Project	IEEE 802.16 Broadband Wireless Access Working Group <http://ieee802.org/16>	
Title	Modification of HO process SDLs	
Data	2004-06-25	
Submitted		
Source(s)	Jaesun Cha Sungcheol Chang ETRI 161, Gajeong-dong, Yuseong-Gu, Daejeon, 305-350, Korea	Voice: +82-42-860-5587 Fax: +82-42-861-1966 jscha@etri.re.kr schang@etri.re.kr
Re:	This is a response to a Call for comments about IEEE802.16e-D3	
Abstract	The document contains suggestions on modification of HO process SDLs	
Purpose	The document is submitted for review by 802.16e Working Group members	
Notice	This document has been prepared to assist IEEE 802.16. It is offered as a basis for discussion and is not binding on the contributing individual(s) or organization(s). The material in this document is subject to change in form and content after further study. The contributor(s) reserve(s) the right to add, amend or withdraw material contained herein.

Modification of HO process SDLs
Jaesun Cha and Sungcheol Chang
ETRI

2. Proposed changes to IEEE 802.16e-D3

Figure 130k – locally initiated transaction MOB_BSHO-RSP pending state flow diagram

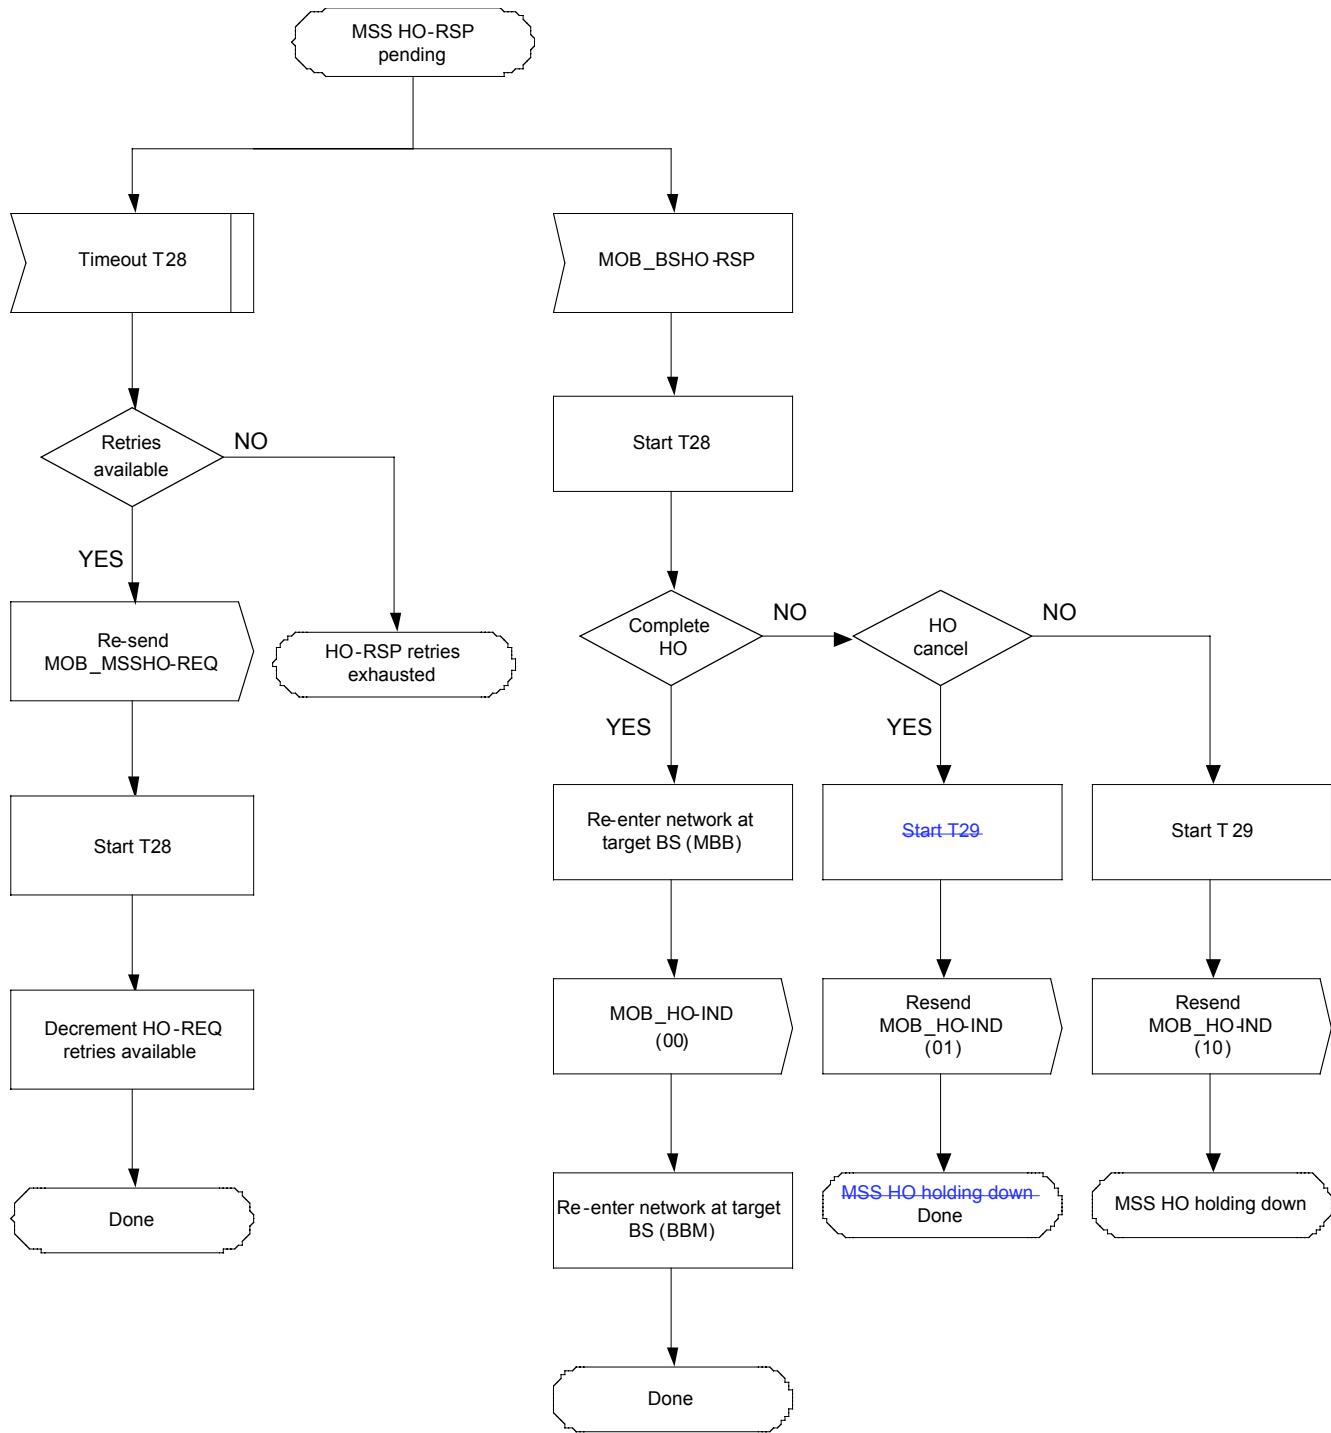
As specified in IEEE P802.16e/D3, after an MSS or BS has initiated an HO using MOB_MSSHO/BSHO-REQ, the MSS may cancel HO at any time. The HO cancellation means the completion of HO-related process. Therefore, after MOB_MSSHO-IND with the HO cancel option (HO_IND_type = 01), MSS and BS should complete handover process. Thus, timer T29 is useless in case of HO cancel. However, HO process SDLs depict that MSS shall wait for MOB_BSHO-RSP even after it sends MOB_HO-IND with HO cancel option.

In addition to the above problem, there is another problem in describing HO reject process. Even though MSS signaled rejection of Serving BS instruction to HO through HO_IND_type field in the MOB_HO-IND set value of 10, the MSS could choose Target BS from new Target BS list which is reconfigured by Serving BS. However, there is no such description in HO process SDLs.

[Change Figure 130k – locally initiated transaction MOB_BSHO-RSP pending state flow diagram]

Figure 1301 – MSS Handoff locally initiated transaction holding state flow diagram

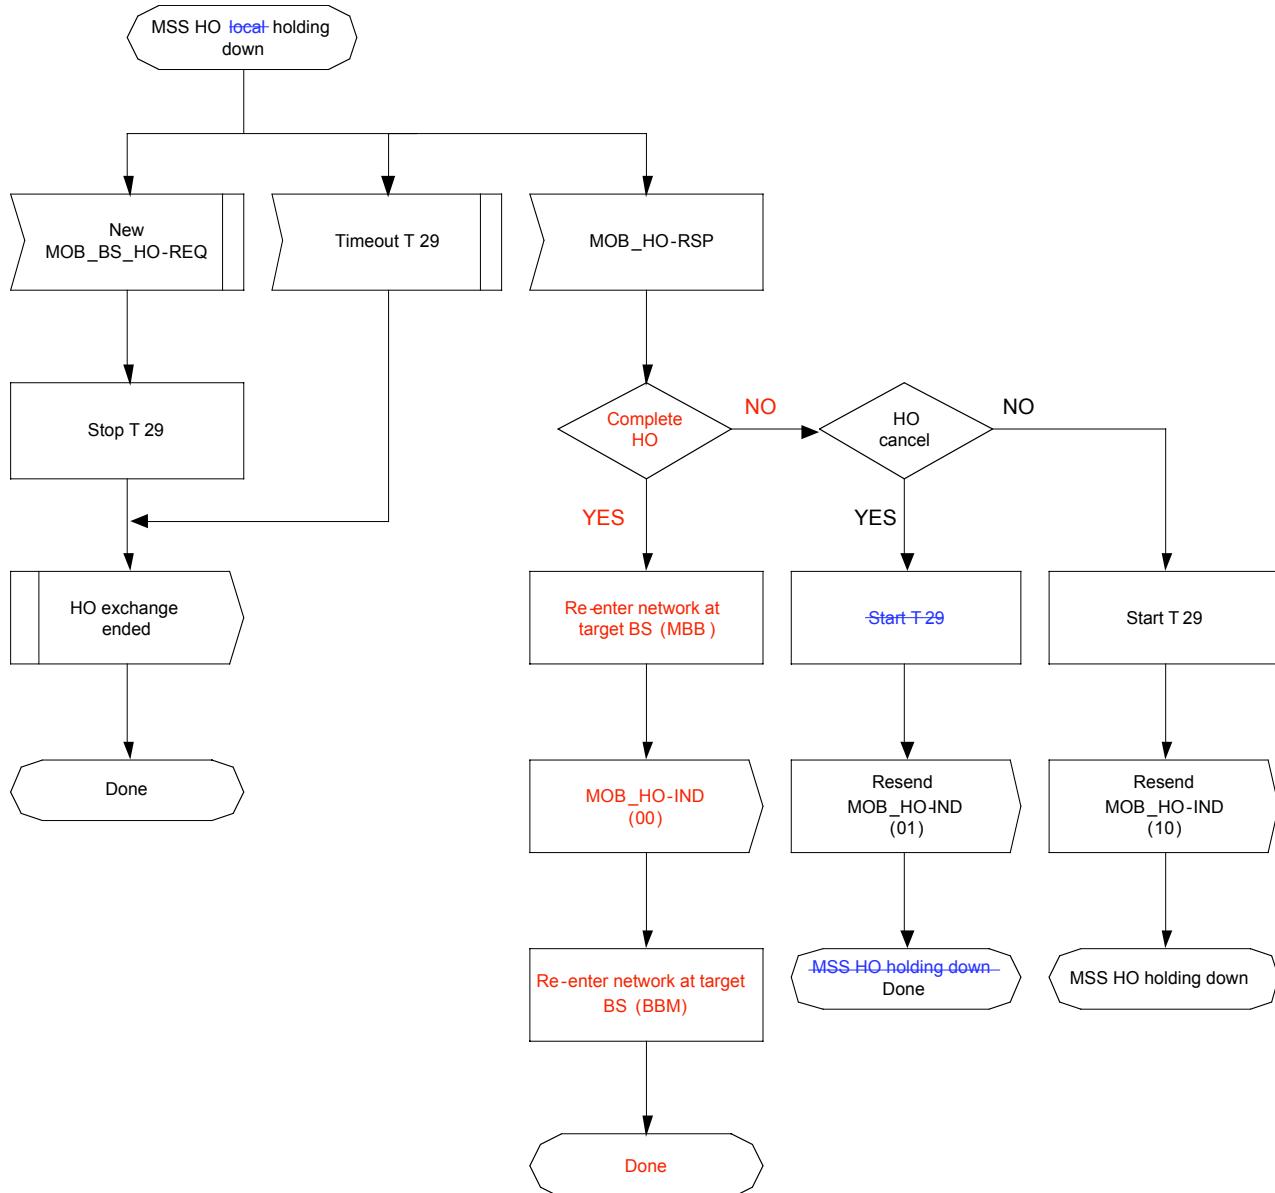
[Change Figure 1301 – MSS Handoff locally initiated transaction holding state flow diagram]

Figure 130m – locally initiated transaction MOB_BSHO-RSP pending state flow diagram

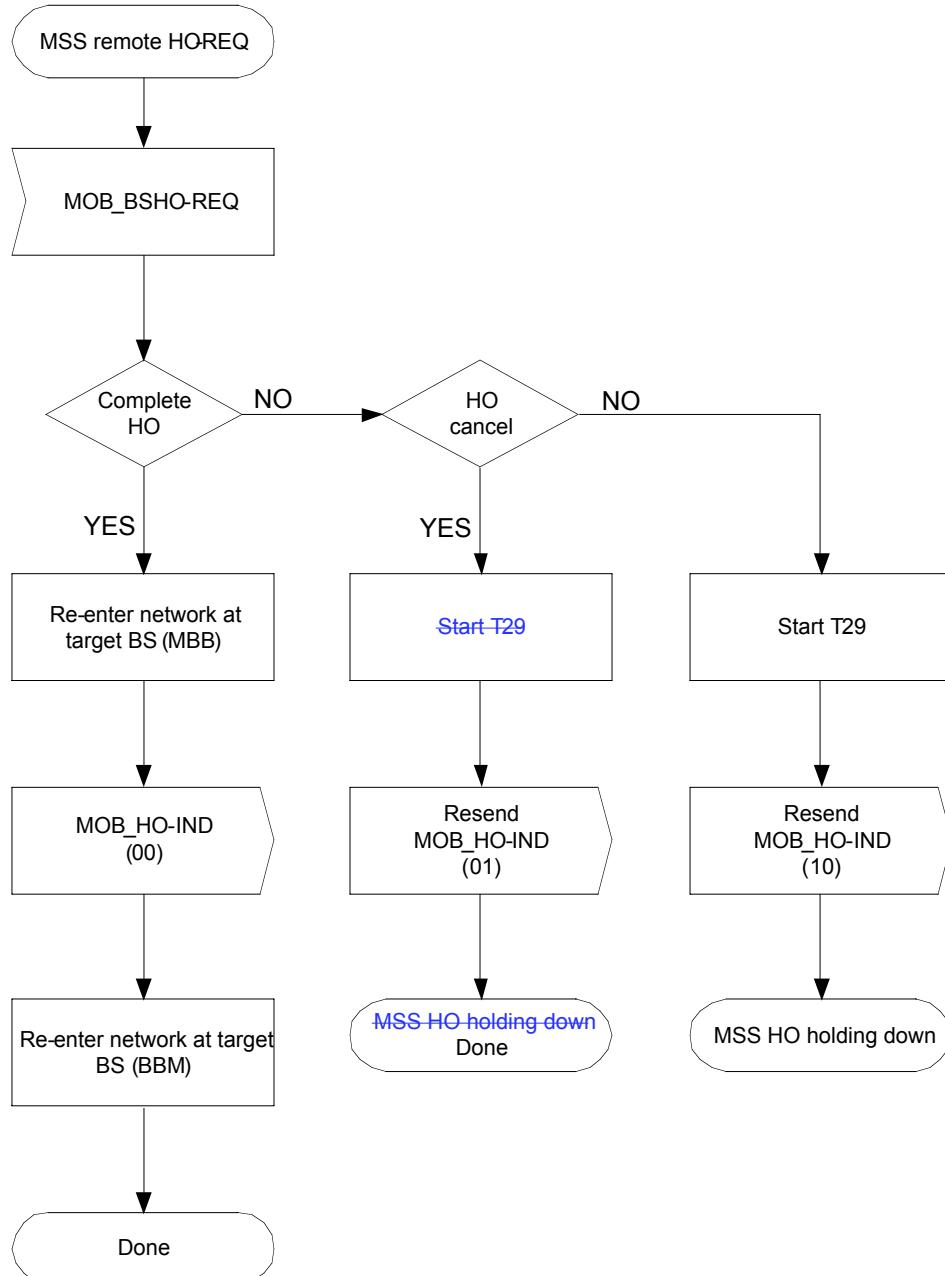
[Change Figure 130m – locally initiated transaction MOB_BSHO-RSP pending state flow diagram]
